Serial No.: 10/801,307

IN THE DRAWINGS

REMARKS

**Fig. 5**

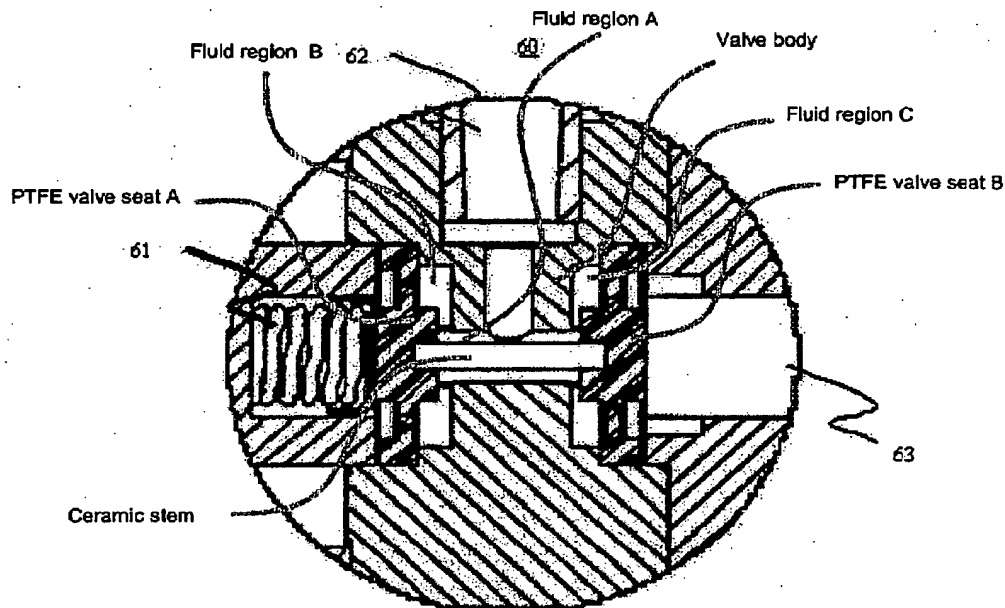
Claims 2, 4, 11 and 19 are rejected under 35 USC § 112, first paragraph as allegedly failing to comply with the enablement requirement. In particular, the Examiner is concerned that one of ordinary skill in the art would not understand how the valve returns to its neutral state. This rejection is respectfully traversed.

As noted in paragraph [0028], the exemplary embodiment 70 of the three-way valve illustrated in FIG 9 involves a modification of a known Takasago three-way valve, which is shown in varying views in FIGS 2-8. As described in paragraph [0002] of the Background, and as perhaps best seen in FIG 5 (presented below with annotations), the existing three-way valve is a pneumatically activated valve (via pneumatically activated plunger 63) with a spring return 61. The existing valve contains an assembly that includes two PTFE valve seats mechanically interlocked with a small ceramic stem ("the assembly"). As can be seen from FIG 5, the PTFE valve seats are fixed such that they can't move horizontally without deformation. Moreover, the PTFE valve seats are elastic and in the absence of any horizontal force (i.e., pneumatic force or spring force), would be centered with respect to the valve body (which is shown in right-hand downward cross-hatching) such that both valve seats are open. However, when the plunger 63 of FIG 5 is pneumatically activated, it drives the assembly to the left. This overcomes the force being exerted by the spring return 61 and allows the PTFE valve seat A to pull away from the valve body, resulting in fluid communication between fluid region A (which is connected to a first common port) and fluid region B (which is connected to a second port). This also pushes the PTFE valve seat B against the valve body, precluding fluid communication between fluid region A and fluid region C (which is connected to a third port). On the other hand, when the pneumatic pressure is removed, the assembly is driven to the right by the spring return 61, forcing the PTFE valve seat A against the valve body, and preventing fluid communication between fluid region A and fluid region B. The PTFE valve seat B, on the other

hand, is pulled way from the valve body, allowing fluid communication between fluid region A and fluid region C. Thus, due to the presence of the spring return in the valve of FIG 5, there is *always* an actuating force, even when the supply pressure operating the valve is removed (e.g., when the valve is not in use). Consequently, there is never a situation in which the assembly is not being urged to the left or right, and thus the assembly is never allowed to become centered with respect to the valve body (due to the elastic rebound of the PTFE material) such that both valve seats are open (i.e., at its "equilibrium" position). Moreover, when the supply pressure operating the valve is removed from the valve of FIG 5, the PTFE valve seat A is forced against the valve body by the spring return, allowing the valve to be glued shut.

In the present invention, on the other hand, both valve seats are pneumatically driven and there is no spring return. Thus, when the pneumatic force is removed from the valve (e.g., when the valve is not in use) the assembly is neither forced to the left nor to the right, allowing the assembly to return to its centered "equilibrium" position wherein both valve seats are open. This completely opens the valve (i.e., establishing fluid communication between fluid region A and fluid region B at

the same time as establishing fluid communication between fluid region A and fluid region C). More importantly, when the spray coat machine of the present invention is not in use, neither valve seat is held closed, which eliminates the possibility of the valve becoming glued shut. See paragraph [0033].
